TECHNICAL BULLETIN

No: JTB00183
Issue: 1
Date: 07 JAN 2010

Air Conditioning System Not Cooling Sufficiently

S-TYPE (X200) 3.0L V6 only

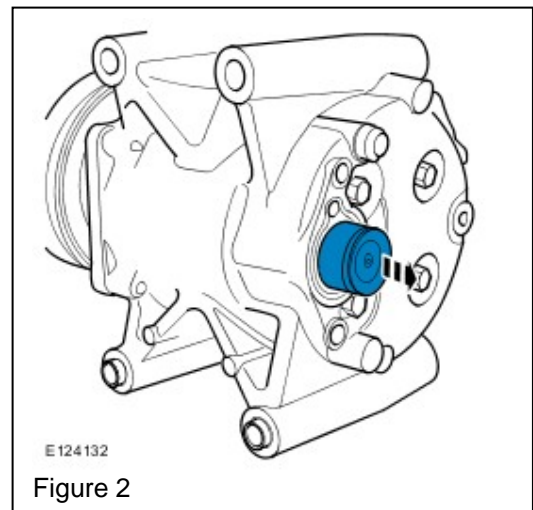
NOTE: A/C compressor shown removed for clarity. Note the position of the cover. (Figure 1)

4. Remove the A/C compressor valve cover:
 - Remove the two bolts.

- Evenly and progressively tighten the bolts to **15Nm (11 lbf ft)**. (Figure 1)

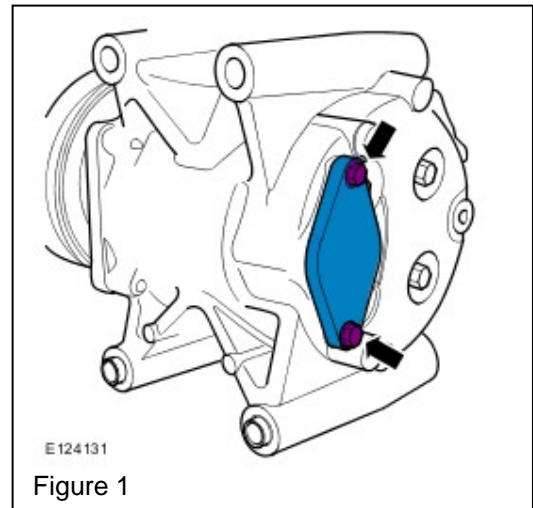
NOTE: Note position of the A/C compressor valve. (Figure 2)

5. Remove the A/C compressor valve. (Figure 2)

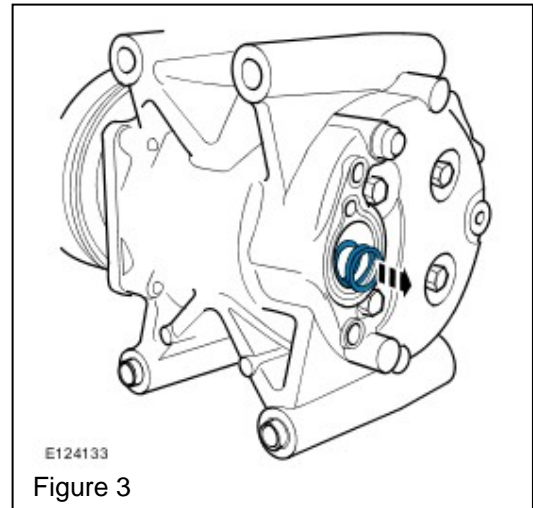
6. Remove the A/C compressor valve spring. (Figure 3)

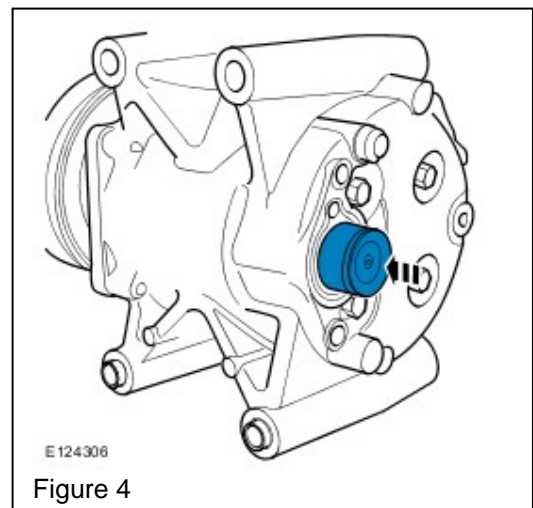
7. Install the A/C compressor valve. (Figure 4)
